# SERVICE BULLETIN

\* Supersedes Service Information Notice No. DN-68, Dated 30 June 1980

## RELOCATION OF TAIL ROTOR BUNGEE SPRING FORWARD ATTACHMENT; TAIL ROTOR FORCE ADJUSTMENT

500D Model 369D Helicopter Serial No. 003D through 0467D

### Figure 1. Relocation of Tail Rotor Bungee Spring Forward Attachment

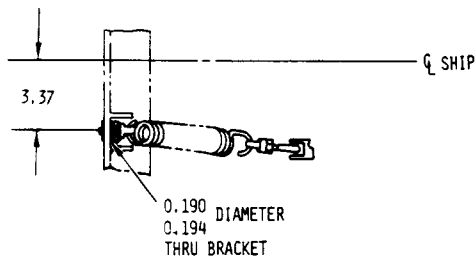
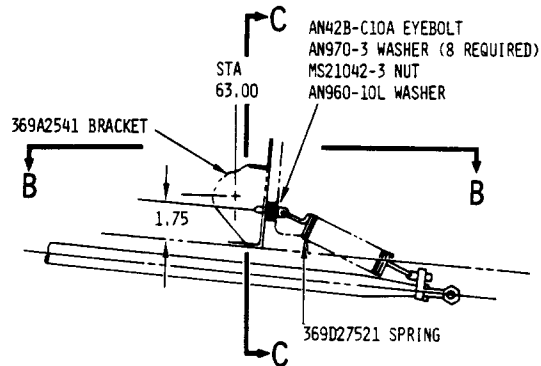
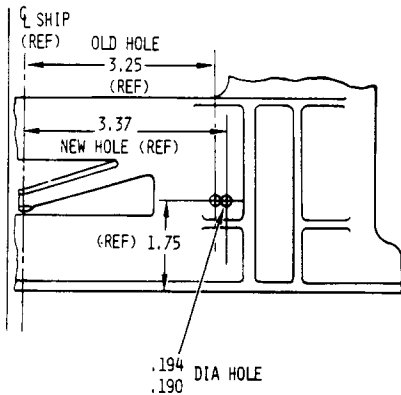
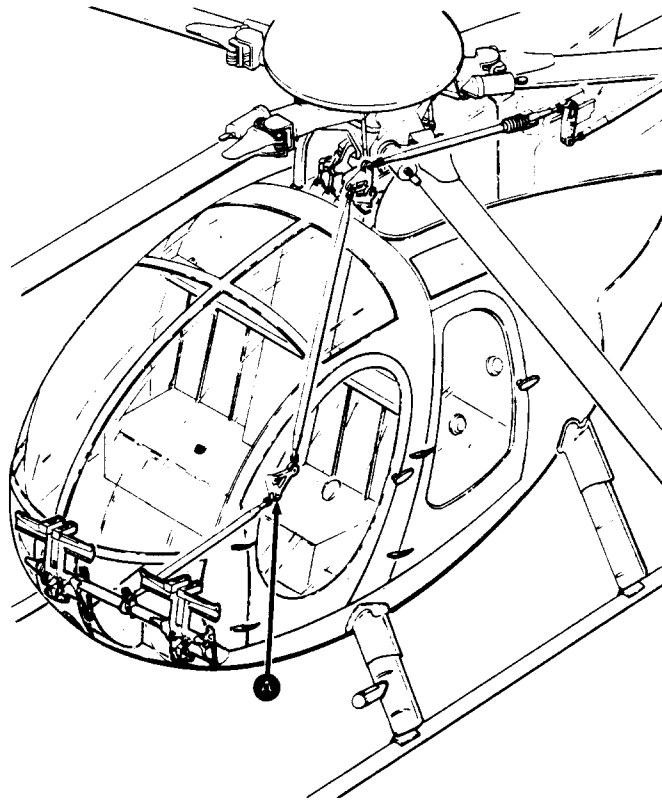
The information given in this Service Information Notice lists a procedure to relocate the tail rotor bungee spring forward attachment to allow installation of washers for bungee adjustment, to adjust for minimum pedal loads in cruise. This revision corrects existing dimensions for the new bungee spring attachment hole location shown in Figure 1.

- c. Disconnect bungee spring from eyebolt and remove and retain nut and washer attaching eyebolt to bracket at Station 63. Discard eyebolt.
- d. Locate position and drill new hole using No. 10 drill. Remove any burrs as required. (See Figure 1. )

- g. Install eight AN970-3 washers on one AN42B-C10A eyebolt and hook forward end of 369D27521 bungee spring to eyebolt. Insert eyebolt in new hole in 369A2541 bracket and secure with washer and nut retained above. Torque nut to 20- 25 in. lbs.

**NOTE:** If tail rotor pedal forces are not zero during level flight at 130 to 140 knots, tail rotor force adjustment may be accomplished by removing a desired number of AN970-3 washers.
